Barangaroo – Commercial Building C3, C4 and C5 MP11_0044, MP10_0025 MOD1 and MP10_0227

Response to Environmental Assessments and Modification request
Submission to the Department of Planning 19 December 2011

19 December 2011

Fig 7. Commercial Building C4 – Site Plan – November 2011

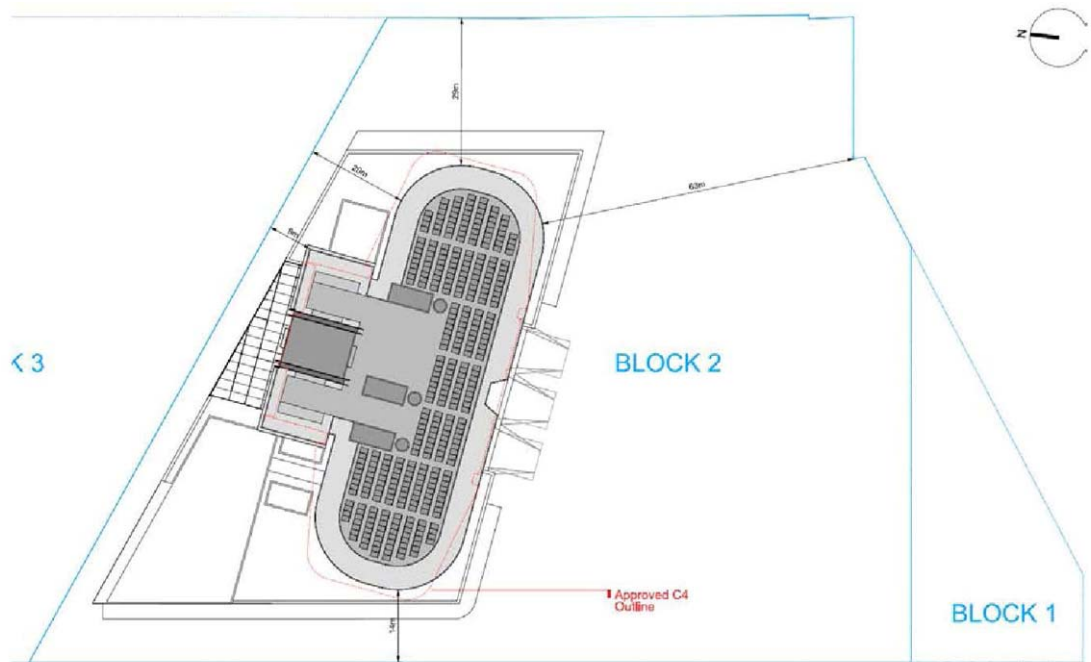
The City has an ongoing concern regarding the total approved GFA under Concept Plan (Mod 4) and the Proponent's ability to comply with that quantum with each individual application assessed without reference to an allocation table.

A potential excessive allocation of GFA results in a potential shortfall of GFA for the remaining buildings within the block and undermines their capacity to deliver the urban design principles. The total GFA for Block 2 is 209,213m². The allocation of

99,432m² to building C4 and 90,576m² to C5 leaves a residual 19,205m² for the remaining buildings, being two lower buildings to Hickson Road (C2 and C6).

Block 3 has a total GFA of 142,669m². The allocation of 115,291m² to C3 leaves a residual of 27,378m² for C1 and C7.

It is essential that the Department double check all GFA calculations presented by the Proponent in light of the previous contentions raised regarding GFA and ability for this precinct to support the increased capacity and include the table in any approval. This should be consistent with the concept plan approval.

Figure 8 Plan showing extent of wind "apron"

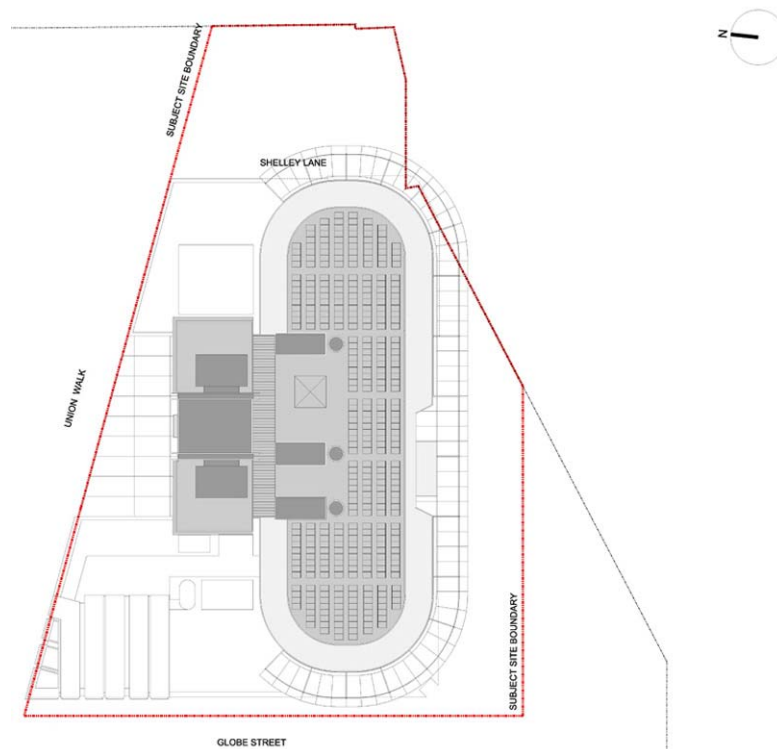
These findings were predicted and are entirely consistent with the City's submission dated 24 September 2010 in section 5.5.2. These predicted problems are generated by a poor urban design process and the procurement process where more emphasis is placed on the size of the buildings rather than the quality of the public space that serves them. The predicted wind effects are generated by very large buildings which are essentially too big and too close together for both their road layout and their exposure to winds across Darling Harbour and from the south. This result is that the building designs cannot ensure that the ground level conditions will be fit for passive comfort without likely substantial overhead glazing, the details of which have not been provided.

It is considered that these adverse wind impacts would be improved by an increase to the height of the tower's podiums as detailed above. This is further discussed in the section **4.0 Architectural Language**. The City also recommends that the height of C5 be reduced to improve wind and shade impacts as it is likely to have the most detrimental impacts on Margaret Street extension and the high pedestrian flows to the ferry wharves.

Figure 13 Required increase in height to the podium as shown in red to address wind wash

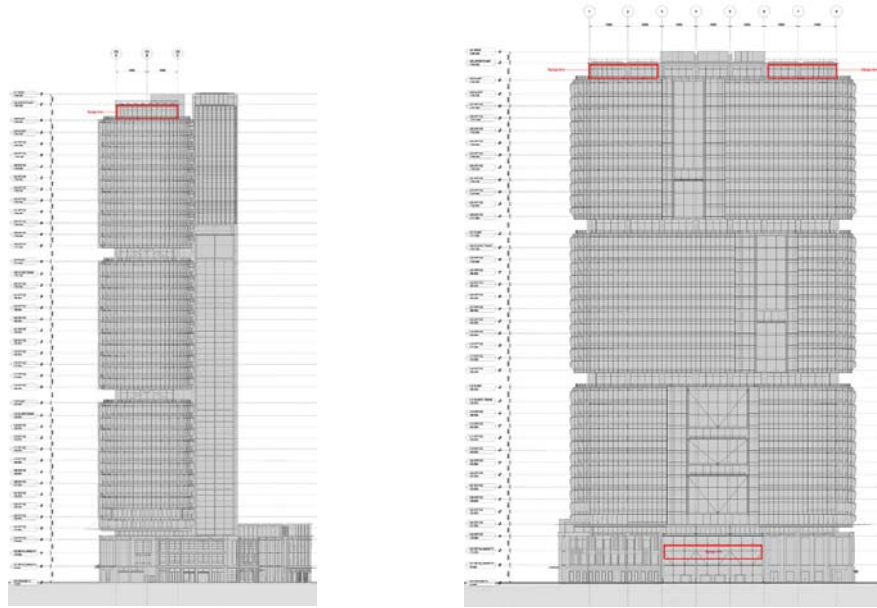
Despite the Department's assessment, the City considers the podiums remain too low to be effective in wind mitigation and street wall. The podiums are considered to be significantly out of proportion with the towers and do not give a sense of enclosure for pedestrians or provide an appropriate human scale for the development. Higher podiums will assist to disguise the height of the towers from pedestrian level.

The proponent's wind reports also suggest that higher podiums are likely to assist in ameliorating wind impacts upon pedestrians.

- The City's control standard of a minimum street frontage height of 22-24 metres should be applied as a minimum to this significant development.
